Access Compliance Report

Public Rights-of-Way

Intersection ID: 52630	Main Street: WEYMOUTH_LN	Cross Street: ALEXANDER_DOWD_DR	Location: NE
ADA ID: 54E35ED40850	Ramp Type: Perp	Initial Pass/Fail: Fail	Overall Compliance: No
		Severity Score: 12.5

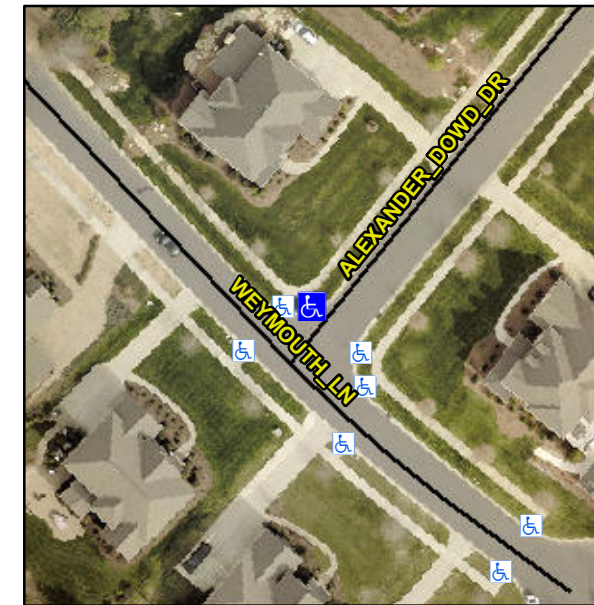
R304.2.2

Compliance	Description	Data	Compliance	Description	Data
N/A	Ramp Length (in)	96.0	No	Ramp Slope (%)	9.1
Yes	Ramp Width (in)	60.0	Yes	Ramp XSlope (%)	1.5
N/A	Flare Type LT	N/A	N/A	Flare Type RT	N/A
N/A	Flare Slope LT (%)	N/A	N/A	Flare Slope RT (%)	N/A
N/A	Flare Traversable LT?	N/A	N/A	Flare Traversable RT?	N/A
N/A	Landing Length (in)	N/A	N/A	DWS Provided?	N/A
N/A	Landing Width (in)	N/A	N/A	DWS Contrast?	N/A
N/A	Landing Slope (%)	N/A	N/A	DWS Length (in)	N/A
N/A	Landing X Slope (%)	N/A	N/A	DWS Full Width?	N/A
N/A	Landing Curb? (Y/N)	N/A	N/A	DWS Offset (in)	N/A
N/A	Shared Landing?	N/A			
N/A	Gutter Ponding?	N/A	N/A	Gutter Slope (%)	N/A
N/A	Gutter Lip Ht (in)	N/A	N/A	Gutter X Slope (%)	N/A
N/A	Painted X Walk1?	No	N/A	Painted X Walk2?	N/A
	X Walk 1 Direction	To SE		X Walk 2 Direction	N/A
N/A	X Walk 1 Width (in)	N/A	N/A	X Walk 2 Width (in)	N/A
	X Walk 1 Slope (%)	3.9		X Walk 2 Slope (%)	N/A
	X Walk 1 X Slope (%)	0.1		X Walk 2 X Slope (%)	N/A

Remove & Replace Entire Ramp.
